SEND_S – ‘mode’ vs. ‘signal’ reconciliation

IEEE P802.3ch Multigig Automotive
Ethernet PHY Task Force

Action Item

NOTE—The recovered_clock arc is shown to indicate delivery of the recovered clock signal back to PMA TRANSMIT for loop timing.
Figure 149–26—PMA reference diagram

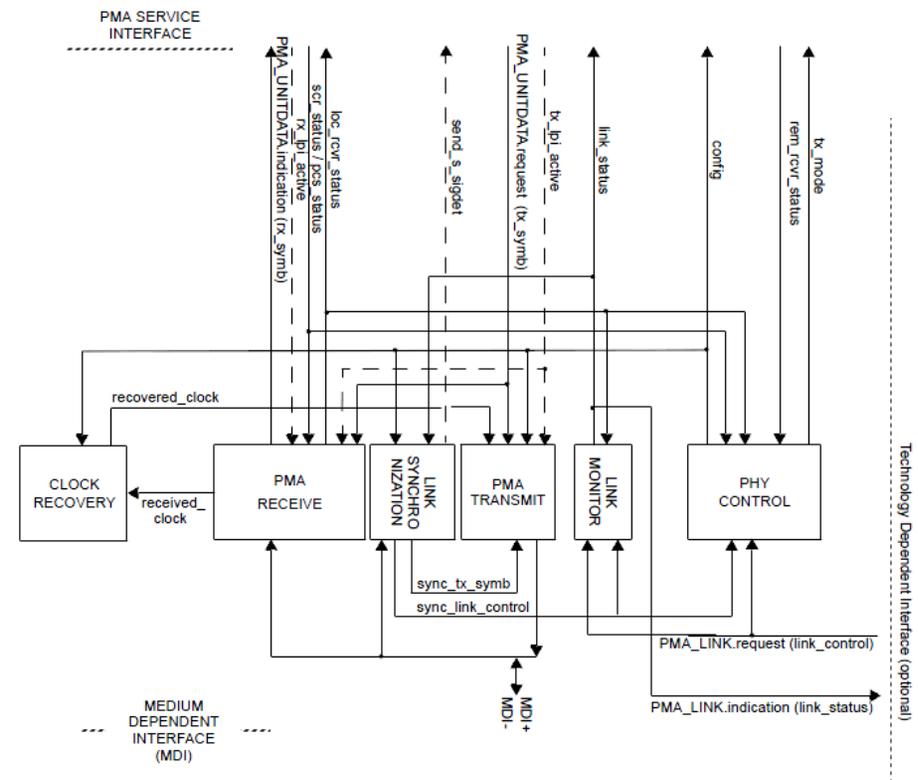
Link Synchronization and Transmitter

- Link Synchronization is a separate function from PMA Transmit
 - When Link Synchronization is active, PMA Transmit takes sync_tx_symb as input
 - This passes SEND_S and SEND_Z to the PMA Transmitter

Excerpt from PHY Link Synchronization state diagram

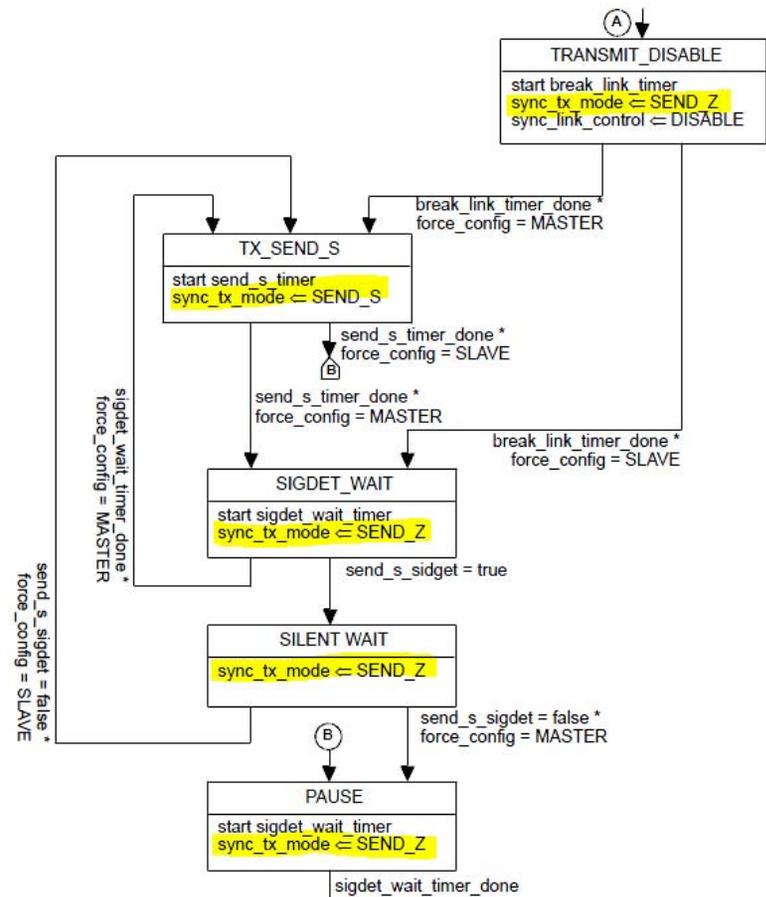
Confusion in Link Synch & PHY control

- SEND_S and SEND_Z are set in sync_tx_mode
 - Defined as a variable in the state diagram
 - NEVER used (only set) and not sent to the PHY control
- sync_tx_symb is NEVER set in the state diagram
 - Defined as the message in the primitive and used in the PHY Control diagram
- Solution:
 - Set sync_tx_symb, eliminate sync_tx_mode

New Description of `synch_tx_symb`

Replace:

“A signal sent from Link Synchronization block to PMA Transmit indicating that a PAM2 (`SEND_S`) or zero (`SEND_Z`) symbol is available.” (P143 L47-48)

With (modified text from P143 L21-25):

“The value of `synch_tx_symb` is set by the Link Synchronization state diagram and indicates the symbols sent from the PHY Link Synchronization block to PMA Transmit.

Values:

- `SEND_S`: this value is asserted to enable transmission of the `SEND_S` signal defined in 149.4.2.6.
- `SEND_Z`: this value is asserted to disable transmission (send zero).”
